## ***Interactive comment on “Hydraulic fracturing in thick shale basins: problems in identifying faults in the Bowland and Weald Basins, UK” by David K. Smythe***

**R. Westaway**

Received and published: 4 March 2016

**Fig. 1.** Please refer to the main document for this Figure caption.

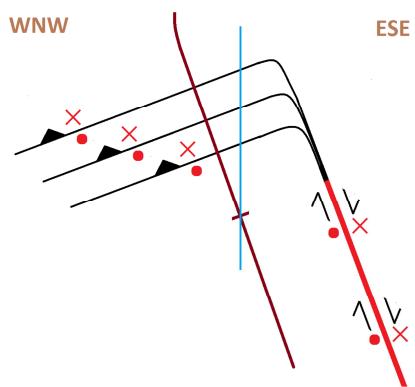
Fourth, Clarke (2016) criticizes the Smythe (2016) interpretation that the 2011 seismogenic fault cut across the Preese Hall-1 borehole, accounting for the observed wellbore deformation. However, as previously discussed (Westaway, 2016b), this struck me as pretty much the most useful aspect of the Smythe (2016) contribution, since it confirms – in general terms – my own stated view; the principal problem with it being that it was based on an incorrect geometry of the fault, having been confounded by some of the mistakes in the original Clarke et al. (2014) publication. From de Pater and Baisch (2011) and Harper (2011), the wellbore deformation was concentrated

between depths of ~8500 and ~8650 feet (MD) (~2591-2637 m MD), equivalent to ~2540-2590 m (TVD). This is close to what was previously interpreted as the top of the Hodder Mudstone Formation, just below the base of the Pendleside Limestone Formation, and is now regarded as near the top of the Lower Bowland Shale, not far below the aforementioned Emstites leion marine band. De Pater and Baisch (2011) reported that the bedding in this vicinity dips WNW at ~30° and the wellbore deformation involved strike-parallel shearing, at an azimuth of ~N30°E, but due to the ambiguity inherent in such measurements (using a multi-fingered caliper tool) had no means of resolving whether the sense of shear was top-to-the-NNE or top-to-the-SSW. This part of the stratigraphic succession consists of interbedded mudstones and limestones; the correlation between the gamma ray log and the wellbore deformation indicates that slip occurred on bedding planes at changes in lithology (cf. de Pater and Baisch, 2011; Harper, 2011). Clarke (2016) is correct to note this interpretation of bedding plane slip, but it does not mean that the slip was not caused by the induced seismicity; the Dusseault et al. (2001) reference cited by Clarke (2016) indeed includes examples of bedding plane slip caused by seismicity. Figure 1 indicates schematically in cross-section how this bedding plane slip might have linked to the coseismic faulting; the inferred geometry resembles a conventional ‘horsetail splay’ (e.g., Sylvester, 1988) or ‘contractional imbricate fan’ (e.g., Woodcock and Fischer, 1986) fault termination. From consideration of the magnitude (2.3) and, thus, seismic moment, of the largest Preese Hall induced earthquake, a coseismic displacement of ~10 mm can be estimated (cf. Westaway and Younger, 2014); it is envisaged that, beyond the up-dip limit of this fault, this shear displacement would have been partitioned across the various planes of weakness within the deformed zone. One reason why this wellbore deformation has not hitherto been associated with the induced seismicity was that Clarke et al. (2014) located the seismicity so far from the wellbore. This argument was superseded by the realisation of the mistakes in their paper and the resulting adjustment of the position of the seismogenic fault much closer to the wellbore (Westaway, 2016a). Another reason has been because de Pater and Baisch (2011) were unable to identify a clear con-

ceptual link between the seismogenic fault and the wellbore deformation. Since such a link is now evident (Fig. 1), this issue warrants further attention. In the meantime, I note in passing that Clarke's (2016) comment that 'all of the evidence collected to date supports the observation that the wellbore was within 300 m of a fault but does not intersect it' is not in fact correct. On the contrary, it would appear that the wellbore intersected the 'horsetail splay' or 'contractional imbricate fan' at the up-dip termination of this fault (Fig. 1); by most definitions this is regarded as part of the fault.
